CONSTRUCTION PLANS
FOR
HILTON PLACE STORM DRAIN

HYDROLOGY DIVISION
PUBLIC WORKS DEPARTMENT
CITY OF ALBUQUERQUE

PROJECT NO. 3955.90

RECORD DRAWING

CITY OF ALBUQUERQUE PUBLIC WORKS DEPARTMENT ENGINEERING GROUP	
TITLE:	HILTON PLACE STORM DRAIN PLAN & PROFILE-WEST HALF

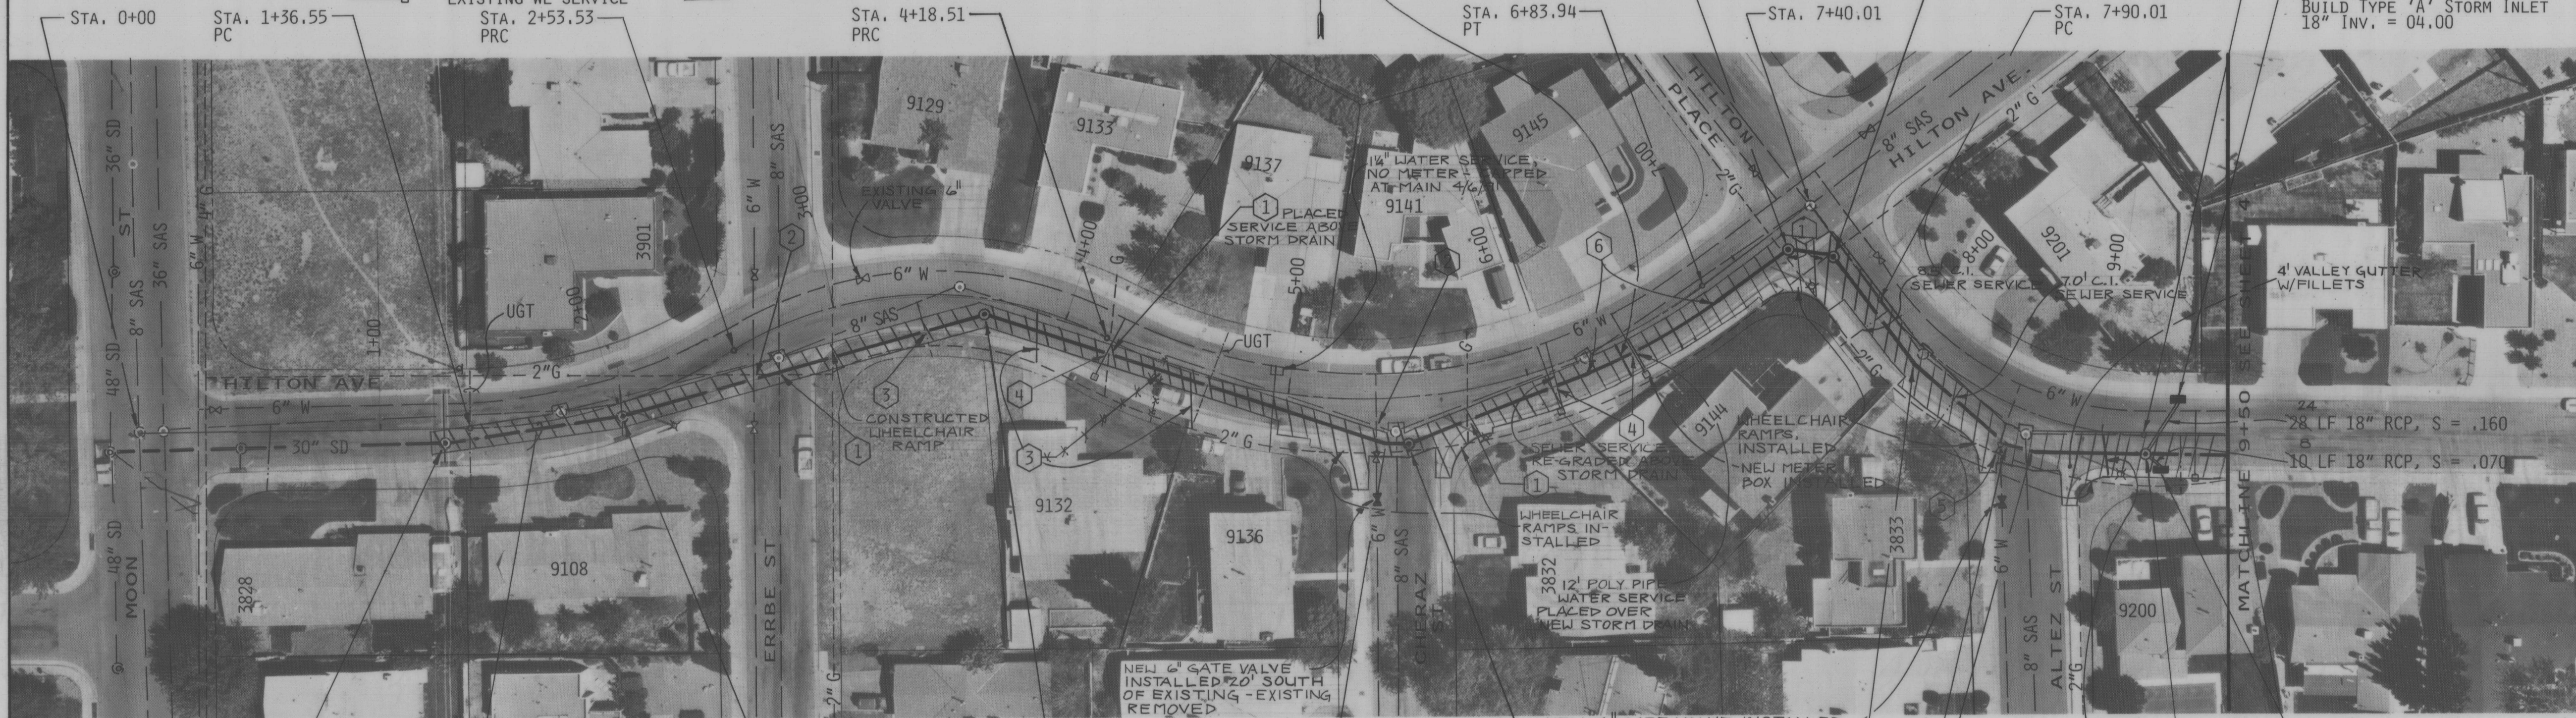
MH No. 1
EXISTING MH
REMOVE EXISTING 24" LINE
@ MH, ENLARGE OPENING,
AND INSTALL NEW 30" LINE.
~~GROUT ANNULAR SPACE CLOSED.~~
REMOVED EXISTING 4' DIA. MH
& REPLACED W/6" DIA. TYPE 'C' MH

-MH NO. 2
EXISTING MH
SAME NOTE FOR MH NO. 1
APPLIES, ALSO BREAK OUT
EAST SIDE AND INSTALL
NEW 30" LINE EAST. GROUT
ANNULAR SPACES CLOSED,
REMOVED. EXISTING 4" DIA. MH
& REPLACED W/6" DIA. TYPE 'C' MH

NEW 6" GATE VALVE INSTALLED
22' SOUTH OF EXISTING -
- MH NO. 4 EXISTING REMOVED
OPP. STA. 5+49.26, 18.83' RT.
 $\Delta = 9^{\circ}57'49''$ LT.

- 1 REGRADE/RE-ALIGN EXISTING GAS LINE, IF REQ'D, TO ACCOMMODATE NEW STORM DRAIN LINE.
- 2 LOWER EXISTING WATER LINE TO ACCOMMODATE NEW STORM DRAIN LINE. SEE DETAILS SH. 6
- 3 LOCATE EXIST. SAS SERVICE IN ADVANCE & REGRADE IF REQ'D, TO ACCOMMODATE NEW STORM DRAIN. REGRADED SERVICES W/10' C.I., 3"± BELOW NEW STORM DRAIN
- 4 REGRADE EXISTING WATER SERVICE LINE, IF REQ'D, TO ACCOMMODATE NEW STORM DRAIN LINE. INCIDENTAL COST TO CONSTRUCTION.
- 5 REMOVE & RESET VALVE BOX. SUPPORT WATERLINE IF REQUIRED. (INCIDENTAL)
- 6 ~~OPP. STA. 6+25.38 TO OPP. STA. 6+83.94 (7.40' RT) INSTALL STORM DRAIN LINE ON CURVE, Δ = 14°09'34", LENGTH = 60.39', SUPPLY AND INSTALL 8 BEVELED RCP JOINTS WITH 1"46' BEVELS.~~
~~BEVELED JOINTS DELETED, RCP LAID ON CURVE.~~
